DOMESTIC BUILDING ASSESSMENT REPORT

DBDRV-2017-6-1436

29 Stones Rd DEREEL VIC 3352

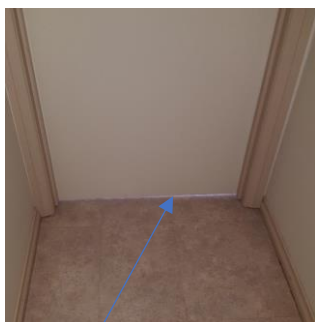
Item three: The floor levels are different between the bathrooms and laundry, where the floors are tiled with ceramic tiles, and the rest of the house, which is covered with vinyl tiles. There is a difference in the floor level of 9 mm (the vinyl floors are lower).

Level difference 9 mm

Reasons and observations

Is this item defective?

No, it is not defective.

Gap under doors

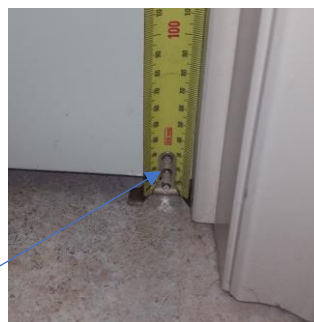
Item four: *The floor is uneven, with differences of up to 5 mm. The gap under the door of the main bedroom is several millimetres higher on the right than on the left.*

Approx. 4 mm difference across doors measured

1. A visual assessment was carried out of the floor levels to bedroom door, Dining & Living floors.
2. The assessment revealed that when an automatic levelling laser level was applied to the Dining Living floor and the levels were within 4 mm of each other in any 2000 mm direction. Within the whole area there was a difference of up to 5 mm.
3. Under doors a difference was noted of up to 4 mm side to side.
4. In accordance with the *Guide*, floors must not differ by more than 10 mm in any room or area. Therefore the item is not defective.

Is this item defective?

No, it is not defective.
